Figure 3.4.11-1 (page 1 of 1)
RCS Pressure Versus Minimum Reactor Vessel Metal Temperature

CLINTON

Technical Specification Bases Changes

B 3.4.11 RCS Pressure and Temperature (P/T) Limits

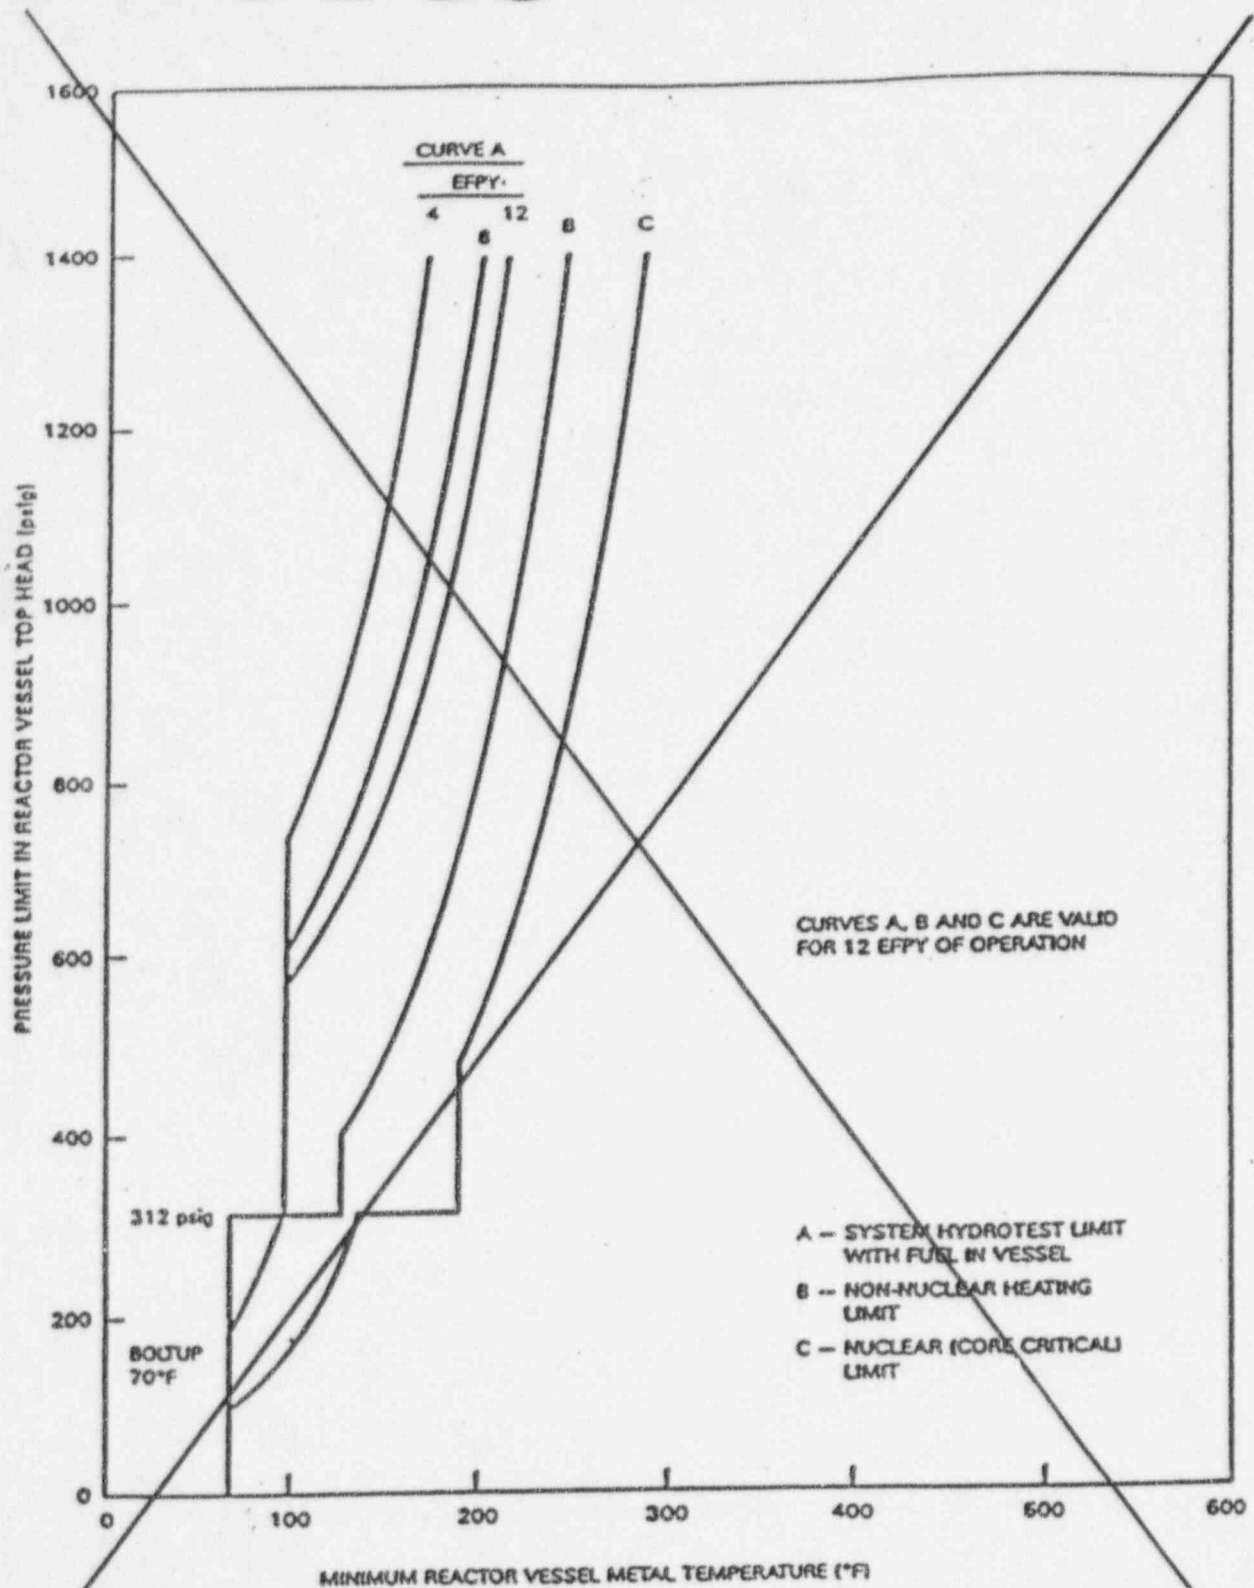
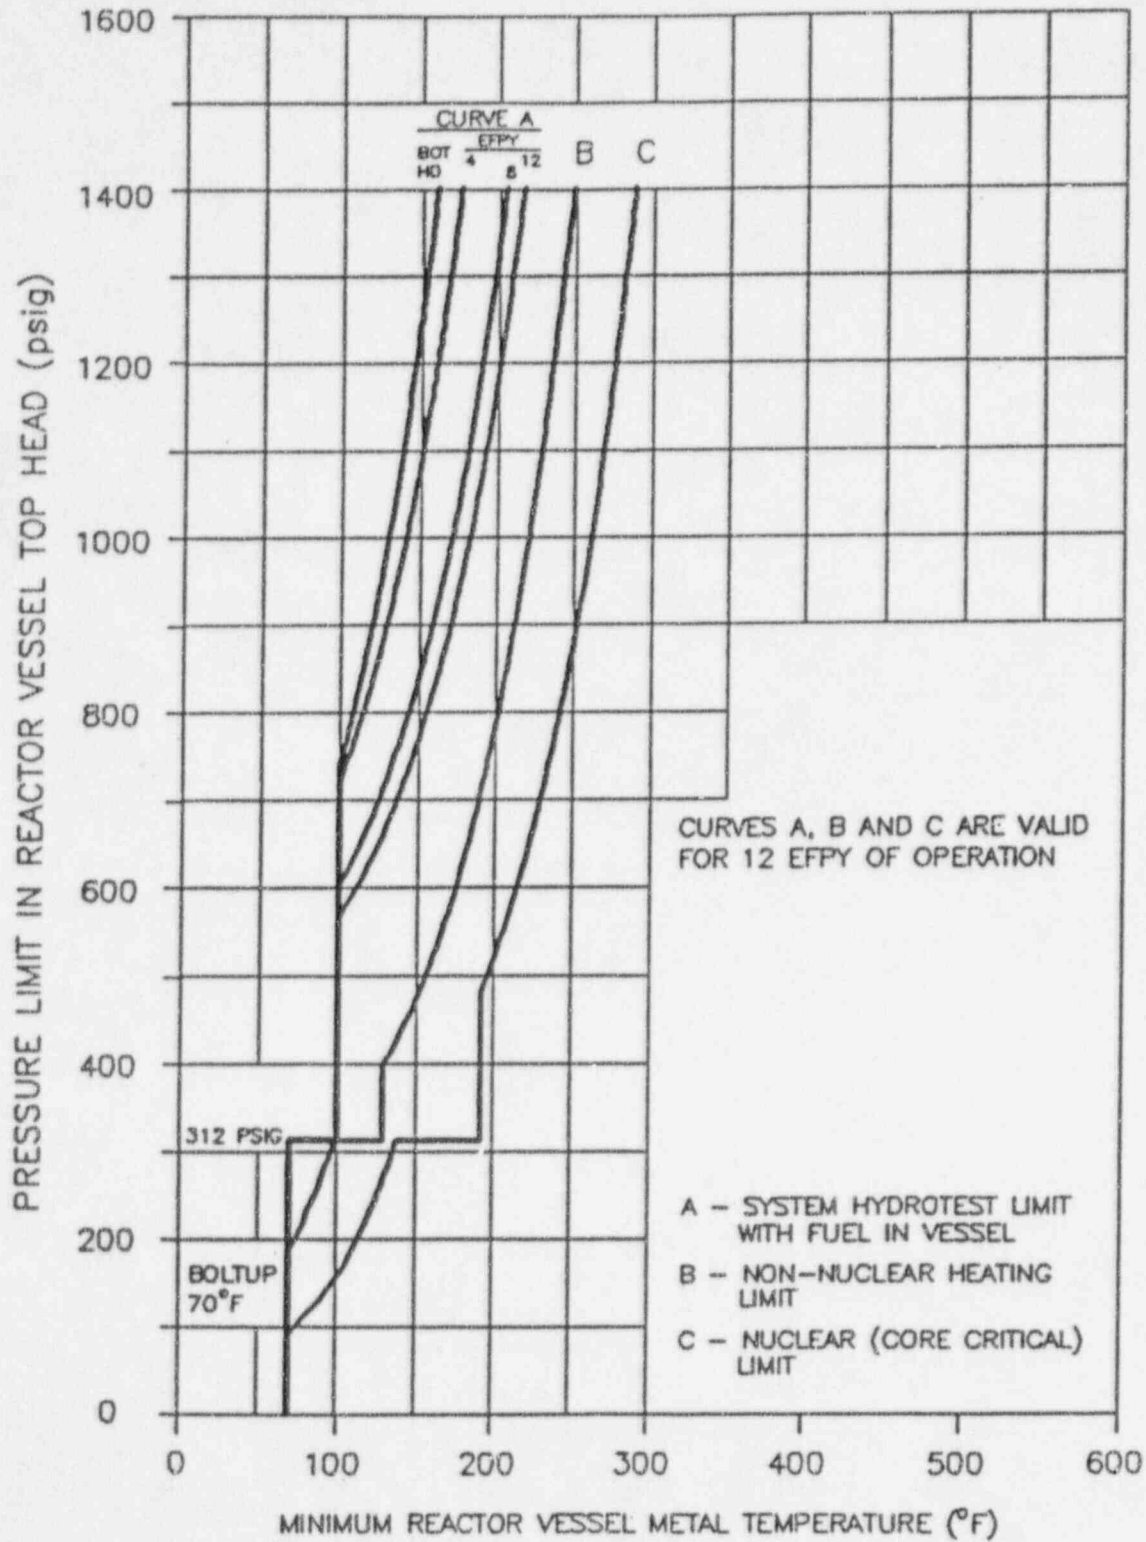
In addition, Curve A includes a separate P/T limit curve for the reactor pressure vessel bottom head to account for the fact that during leak and hydrostatic pressure testing, the bottom head temperature may be cooler than the higher elevations of the vessel if the recirculation pumps are either stopped or operating at low speed, and injection through the control rod drives is used to pressurize the vessel.

Figure 3.4.11-1 contains P/T limit curves for heatup, cooldown, and inservice leak and hydrostatic testing. ~~The P/T limit heatup curve provides limits for both heatup and criticality and is valid for 12 Effective Full Power Years (EFPY) of operation.~~ Curves B and C are based on core beltline conditions with an assumed 130°F shift from an initial weld RT_{NDT} of -30°F. Curve A includes beltline adjusted reference temperatures (ARTs) of 58°F for 4 EFPY, 88°F for 8 EFPY, and 100°F for 12 EFPY. ↑
